Southern Water

Our Ref: SWS-SUSXW-BO-001314

Building Over/Adjacent to Public Sewers - Building Regulations 2000 (as amended).
Location: Seaside Primary School, Freshbrook Road, Lancing, West Sussex BN15 8DL.

O.S. REF: TQ1804SE	Scale: 1:2500	Printed By: chandro	Date: 27-9-2013
Sewer Plot		Southern Water MapGuide Browser	
WARNING: BAC pipes are constructed of Bonded Asbestos Cement		Requested By:	
WARNING: Unknown (UNK) materials may include Bonded Asbestos Cement

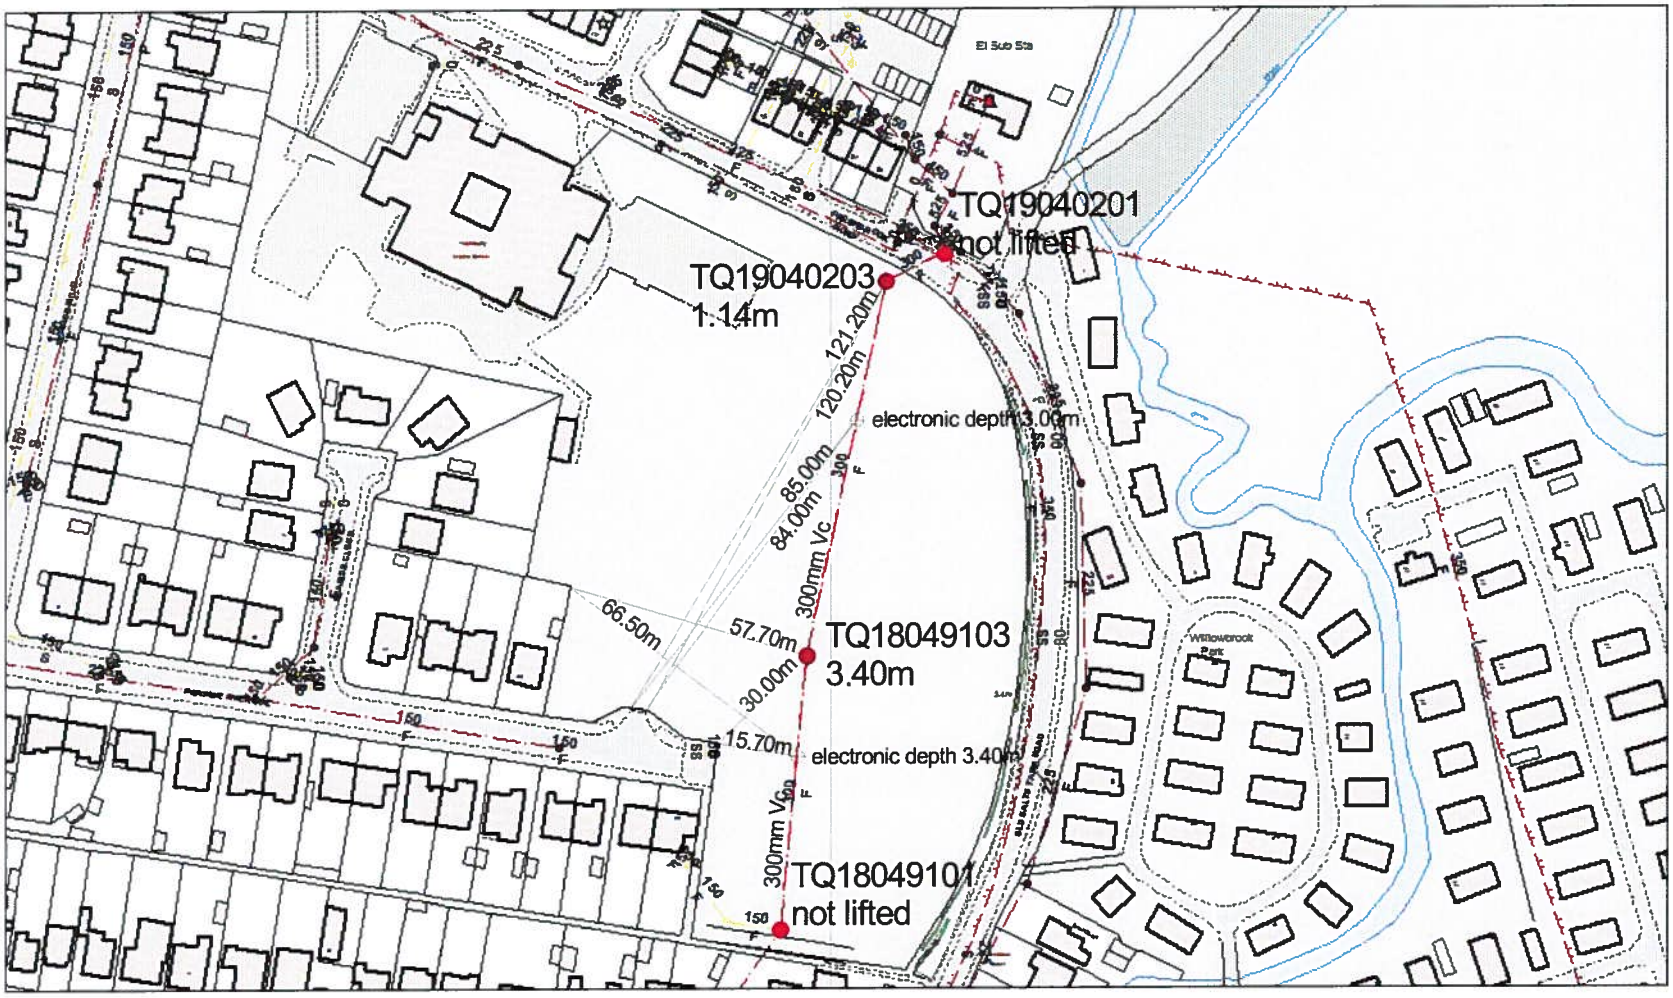
1) Six copies of the detailed drawings to incorporate the items detailed above, indicating the length of sewer affected by the works and being built over marked "A-B" and coloured red. Please see attached marked plan confirming the sewer line for the above requirement. The perimeter of the site should be coloured green.
